CUMMINS WARRANTY MEMO

Subject: Notification Regarding a Safety Defect for certain ReCon Electronic Control Modules of Part Number 3684275RX

Number: m1934 **Date:** 22-Nov-2019

Figure 1 - Location of ECM Serial Number

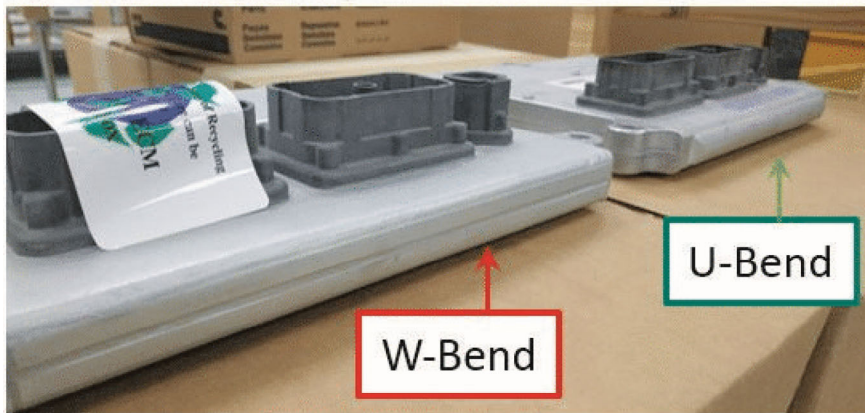
Check the serial number of any remanufactured ECMs Part Number 3684275RX in your inventory to identify any ECMs having a serial number with a prefix of A or B. See **Figure 1** to locate the serial number. To assist you in identifying these ECMs, those having a serial number with a prefix of A or B have a "W-Bend". ECMs having a serial number with a prefix of C (not included in the recall) have a "U-Bend". See **Figure 2** below to distinguish between the two.

If you find any ECMs having a serial number with a prefix of **A** or **B**, follow the Return Goods Process under **CSCO-Alert-2019-0030**.

Figure 3 – Location of ECM on Engine

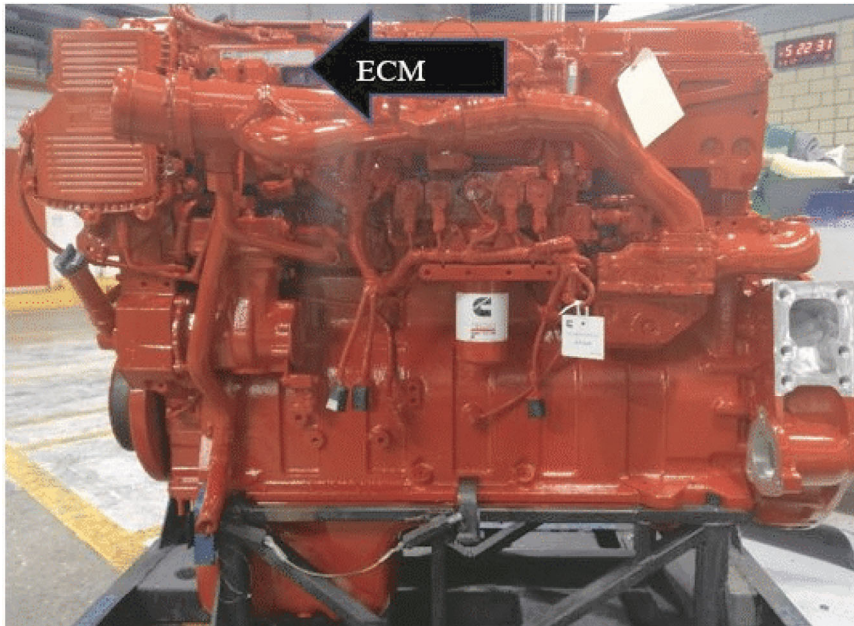
Also check any of the remanufactured engines in your inventory having the part numbers identified above to identify if any of them contain any ECMs having a serial number with a prefix of A or B. See **Figure 3** for the location of the ECM on the engine and **Figure 4** for the location of the ECM serial number.

If you find any ECMs having a serial number with a prefix of **A** or **B** on the Recon Engines, follow the instructions in **CSCO-Alert-2019-0073**. Repair and reimbursement instructions will be detailed in Safety Campaign #**C2253** "ISX CM871 Engine Control Module Safety Campaign," which will be published on QuickServe® Online.

W-BEND AND U-BEND

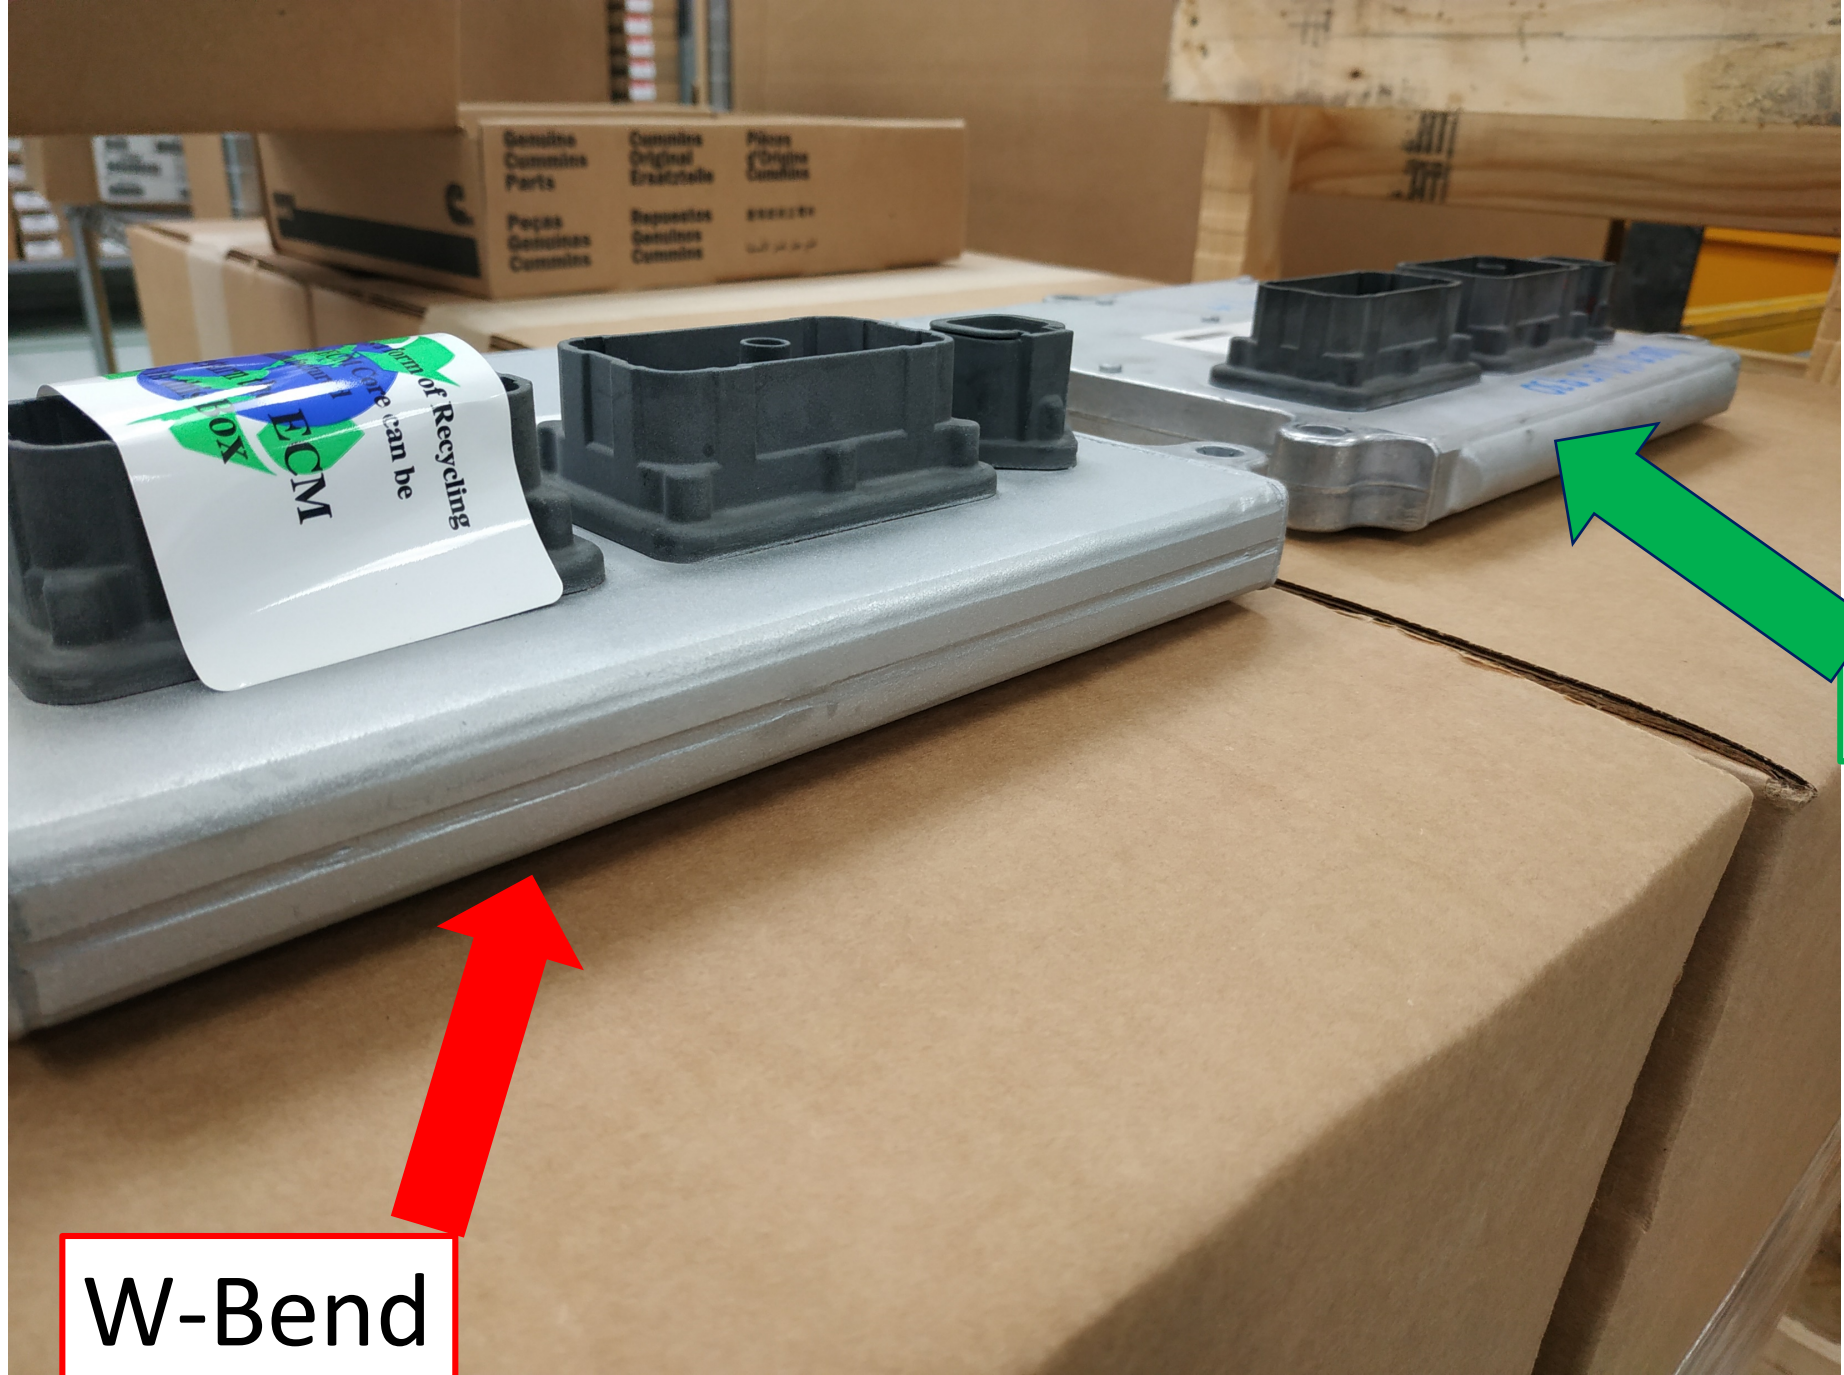
This part number has two different types of housing (W-bend and U-bend). Only W-Bend type model type module is affected by this condition.

Serial numbers for W-Bend start as 6EC871B and square shaped back edge (Review attached PPT slide for more information).

Put on hold and put part qtys in the Response field below.

ECM Serial Number is located in Module data plate

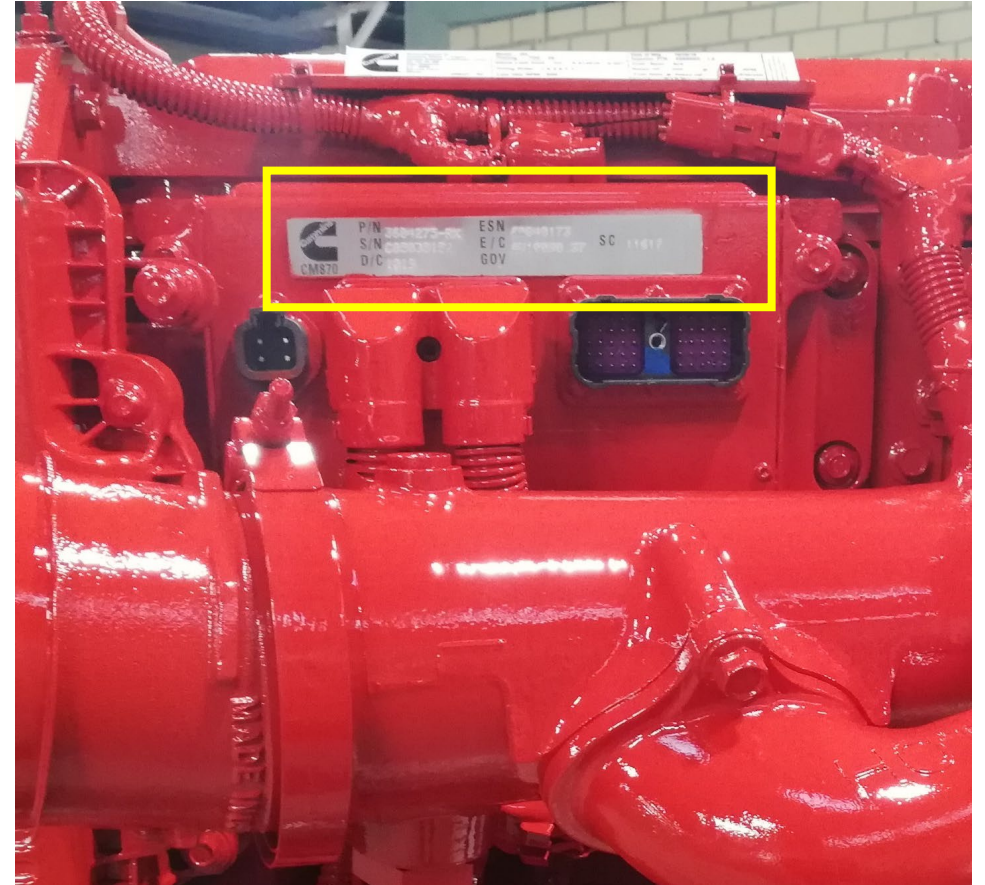
ECM Serial Number affected starts with **A** or **B**

Inspection Plan [ReCon Engines-ECM identification.pptx](#)
 Replace module with a ReCon Electronic Control Module.
